Access Compliance Report

Public Rights-of-Way

(Curb Ramps)

Intersection ID: 48955	Main Street: ROYA_PL	Cross Street: DAVID_JENNINGS_AV	Location: E
ADA ID: 13FB2230A914	Ramp Type: Perp	Initial Pass/Fail: Fail	Overall Compliance: No
Severity Score: 26.25			
Codes/Mitigation Info/Possible Solution		Field Measurements/Component Compliance

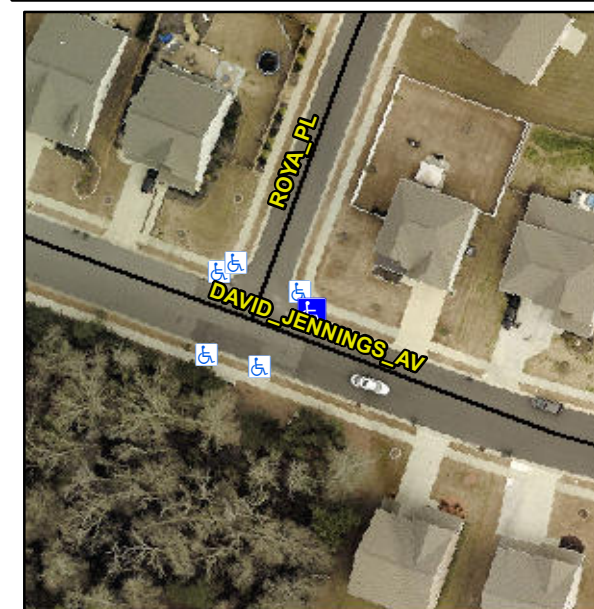
Not Found, R304.2.2

Compliance	Description	Data	Compliance	Description	Data
N/A	Ramp Length (in)	54.5	No	Ramp Slope (%)	16.0
Yes	Ramp Width (in)	48.5	Yes	Ramp XSlope (%)	2.3
N/A	Flare Type LT	N/A	N/A	Flare Type RT	N/A
N/A	Flare Slope LT (%)	N/A	N/A	Flare Slope RT (%)	N/A
N/A	Flare Traversable LT?	N/A	N/A	Flare Traversable RT?	N/A
N/A	Landing Length (in)	N/A	N/A	DWS Provided?	N/A
N/A	Landing Width (in)	N/A	N/A	DWS Contrast?	N/A
N/A	Landing Slope (%)	N/A	N/A	DWS Length (in)	N/A
N/A	Landing X Slope (%)	N/A	N/A	DWS Full Width?	N/A
N/A	Landing Curb? (Y/N)	N/A	N/A	DWS Offset (in)	N/A
N/A	Shared Landing?	N/A			
N/A	Gutter Ponding?	N/A	N/A	Gutter Slope (%)	N/A
N/A	Gutter Lip Ht (in)	1.5	N/A	Gutter X Slope (%)	N/A
N/A	Painted X Walk1?	No	N/A	Painted X Walk2?	N/A
	X Walk 1 Direction	To SW		X Walk 2 Direction	N/A
N/A	X Walk 1 Width (in)	N/A	N/A	X Walk 2 Width (in)	N/A
	X Walk 1 Slope (%)	5.1		X Walk 2 Slope (%)	N/A
	X Walk 1 X Slope (%)	3.4		X Walk 2 X Slope (%)	N/A

Remove & Replace Entire Ramp.
